From: Judith Blakeman [redacted]
Sent: 02 May 2016 16:40
To: 'David Collins'; Peter Maddison
Cc: Complaints; Cllr.Blakeman@rbkc.gov.uk; cllr.r.atkinson@rbkc.gov.uk; Complaints_Dist2
Subject: ExternalRE: Complaint: Safety and Security at Grenfell Tower

Subject: HIU's within the hallways of some Grenfell Tower flats which are located on the existing electrical supply/distribution board cupboard.

14th October 2015

Photograph A

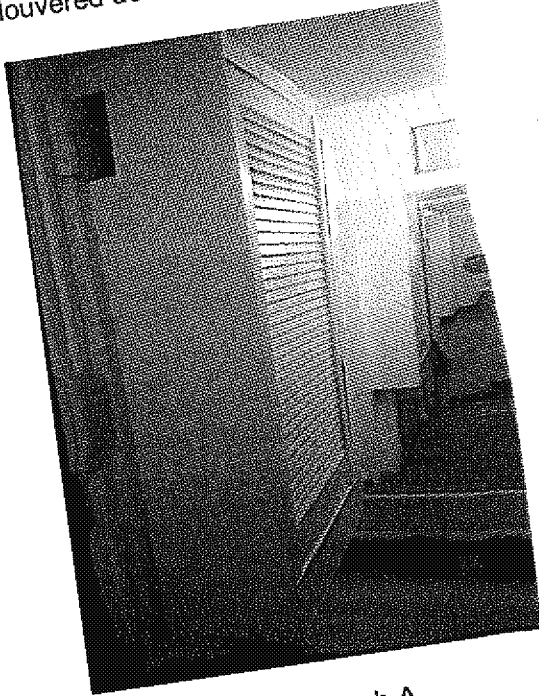
Please see a photograph on the left below, (A) this was taken on Tuesday the 15th December 2015 within one of the flats where the HIU is positioned on the wall just inside of the flat entrance door above the existing electrical cupboard. The local Authority Building Control Officer has agreed the location of this unit in the hallway of the flats concerned and this location complies with the requirements of the Building Regulations. This includes the Fire Safety aspects of the Regulations, so by complying with the requirements of the Fire Safety, Approved Document B of the Building Regulations the positioning also will comply with the requirements of the Regulatory Reform (Fire Safety) Order 2005.

This leaves a clear width/gap of 840mm from the front face of the HIU cupboard to the other wall of the hallway. All of the above measurements were taken from one flat but the width of the hallways is the same within each dwelling and from what I have been told the HIUs have been positioned in similar locations. Photograph C below shows the HIU within the timber constructed cupboard with a louvered door open.

Photopgraph C

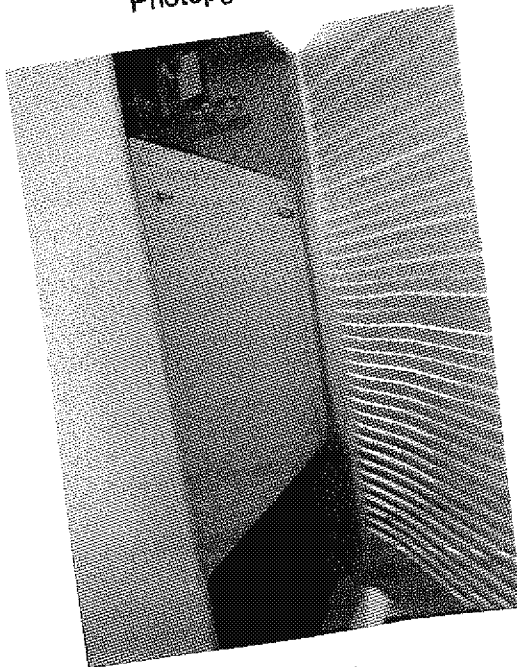
In Approved Document M (ADM) of the Building Regulations, "Access and use of Buildings", which includes disabled access arrangements it states in item 6.23 that the requirements of Part M will be satisfied if an external door providing access for a disabled person, to a dwelling, has a minimum clear opening width of 775mm. The clear width of the hallway within the flat I looked at had a clear width of 840mm, this is greater than the minimum width required by ADM for the entrance door. Again if the requirements of ADM are complied with then the requirements of the Regulatory Reform (Fire Safety) Order 2005, The Disability Discrimination Act 2005 (DDA) and the Equality Act 2010 are also met.

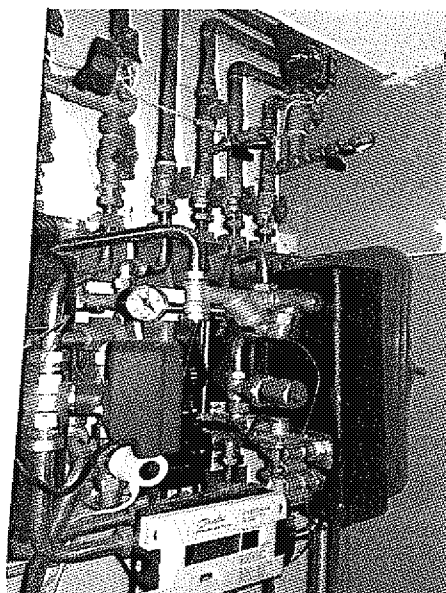
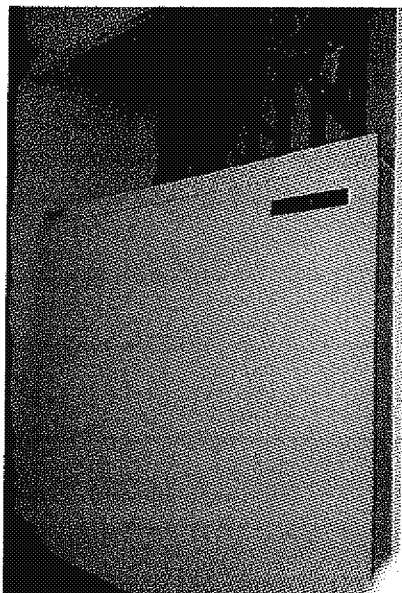
Thank you for asking me to comment on the positioning of the Heat Interface Unit (HIU) within the individual dwellings of this building, the unit, please see a photograph below with the cover on and with it off, are mostly located in the hallway of each individual flat/dwelling. The locations can be seen in a typical flat layout drawing in Appendix A, position A is the hallway location and position B is the kitchen location.

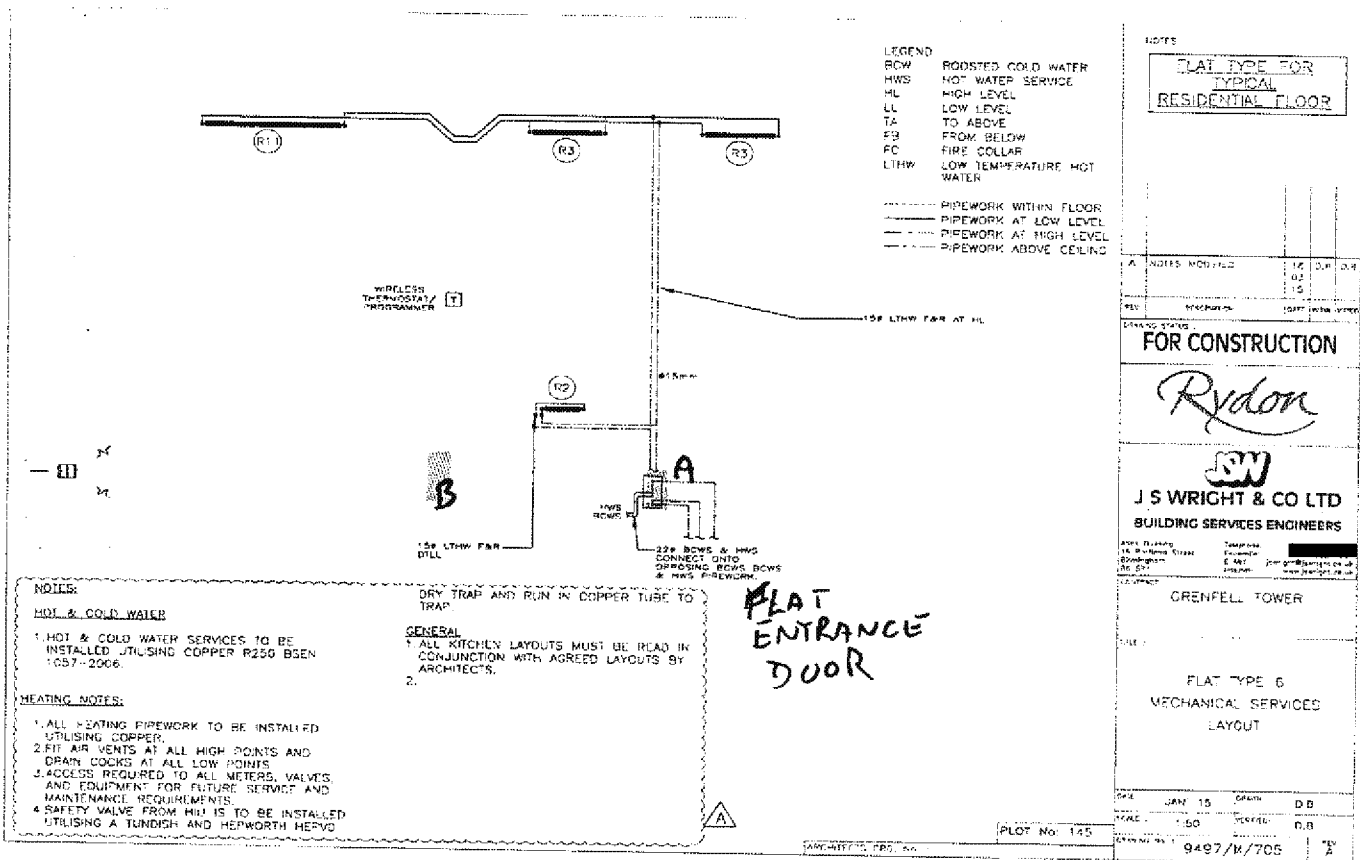
The HIU's are electrically powered/operated with the fused spur located at high level on the hallway wall next to the units, please see the photograph below. The units do not protrude out into the hallway, they are contained within the cupboard space/area off the hallway. In the flats that I looked at yesterday the fire stopping of the pipes and any cabling through the any walls etc had been undertaken. I was told that the area above the unit, where the pipes are located in the 1st photograph will be covered over by a louvered door, as seen in the photograph below, top left hand side.
